NOTICE REMplacement TERMINAL V30 – 33TZ ENCASTRE
V30 Remplacement des références 7245509, 7245510 et 7166780 par le 7580208
V30 – 33TZ Flush-mounted terminal replacement

V30 – 33TZ Flush-mounted terminal replacement
Codes 7245509, 7245510 & 7166780 changed to 7580208
Notice remplacement terminal V30 – 33TZ encastré

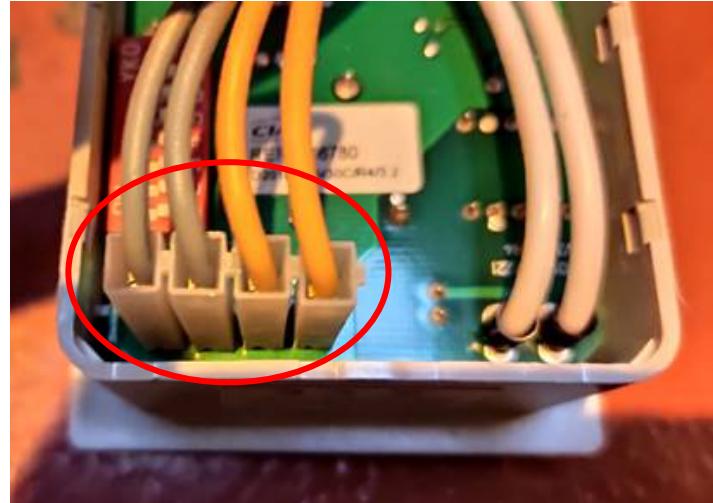
Le nouveau terminal code 7580208 (sans paramétrage) est livré dorénavant sans connecteur 9 fils.

Pour installer le nouveau terminal, il suffira au client de déconnecter l'ancien avec son faisceau 9 fils en prenant soin de conserver les 4 fils jaunes et gris qui relient le connecteur de sonde au terminal V30.

1- Démonter la carrosserie après avoir débroché les deux connecteurs de l'ancien terminal

2- Détacher le faisceau de câbles du terminal de la carrosserie (collier rilsan à couper)

3 - Déclipser l'ancien terminal de la carrosserie

4 - Défaire les 4 cosses fast-on du faisceau sur l'ancien terminal et garder le faisceau 4 fils avec le connecteur 4 fils à son bout.

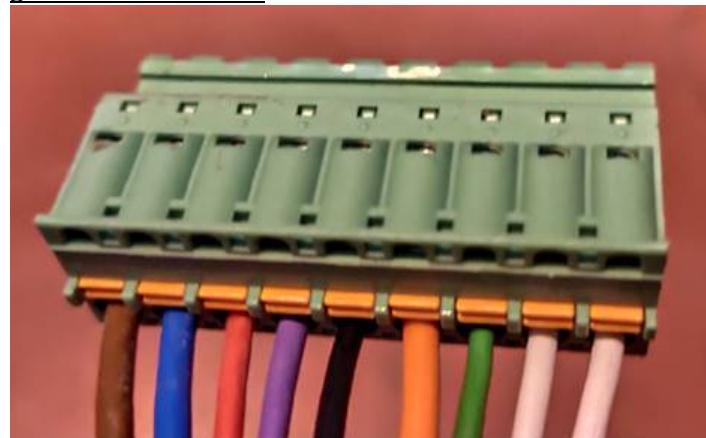
5 -Déconnecter du grand connecteur les 9 fils de couleur du faisceau (appui sur languettes orange) et garder ce connecteur.

6 - Clipser le nouveau terminal sur la carrosserie avec son faisceau 9 fils.

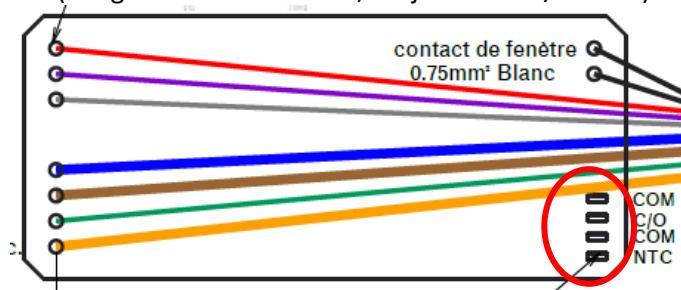
7 - Raccorder les 4 cosses fast-on du faisceau débranché à l'étape 4 sur les bornes fast-on du nouveau terminal
(Fils gris sur NTC et COM ; fils jaune sur C/O COM)

8 - Raccorder les 9 fils nus du nouveau faisceau sur
l'ancien connecteur récupéré à l'étape 5 (respecter le
même ordre des fils de couleur qu'à l'étape 5)

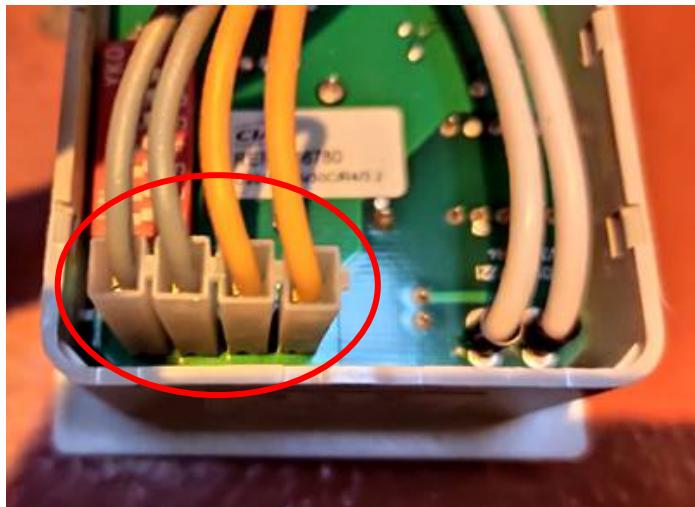
New terminal code 7580208 (w/o parameters) is delivered without its 9-wires connector.

To install new terminal, customer only disconnects the old with its 9-wire beam taking care to keep the 4 yellow and gray wires that connect the sensor connector to the V30 terminal.

1- Disassemble the body after unpinning the two connectors of the old terminal

2- Detach the cable bundle from the body terminal (rilsan straps to be cut)

3 - Unclip the old body terminal

4 - Undo the 4 fast-on beam pods from the old terminal and keep the beam with the 4-wires connector at its end.

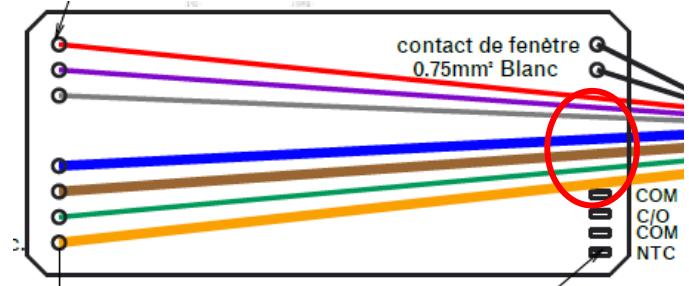
7 - Connect the 4 fast-on pods of the unplugged beam (at stage 4) on the fast-on terminals of the new terminal

(grey wires sur NTC & COM ; yellow wires on C/O COM)

8 - Connect the new beam's 9 bare wires on the old connector kept at step 5 (respect the same order of colored wires)
